## PRODUCT/PROCESS CHANGE NOTICE (PCN)

PCN #: **A1208-02**                      Date: September 6, 2012  
Product Affected: LQFP-144

**PCN Type:** Change of Assembly Location & Exposed Pad Dimension

Exposed Pad Dimension Change

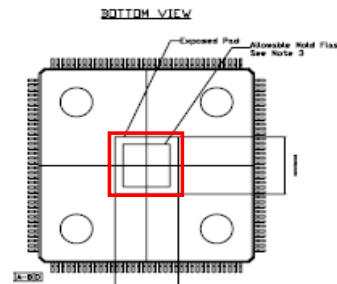
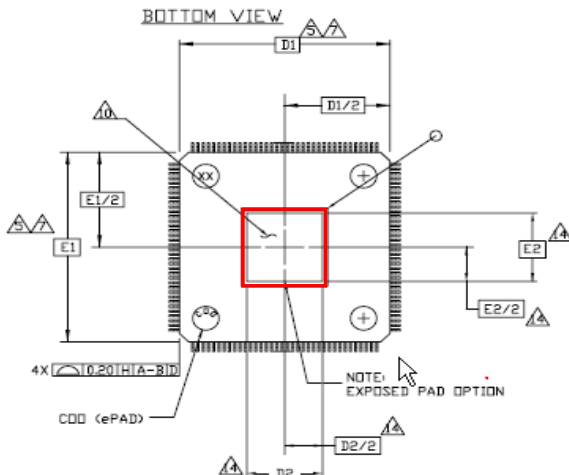
In relation to this assembly location change, the exposed pad dimension will also change from 5.9mm to 6.4mm. Refer attachment for package outline drawing.

**New - 6.4mm**  
(Refer to attached package drawing dimension D2 / E2)

**Old - 5.9mm**
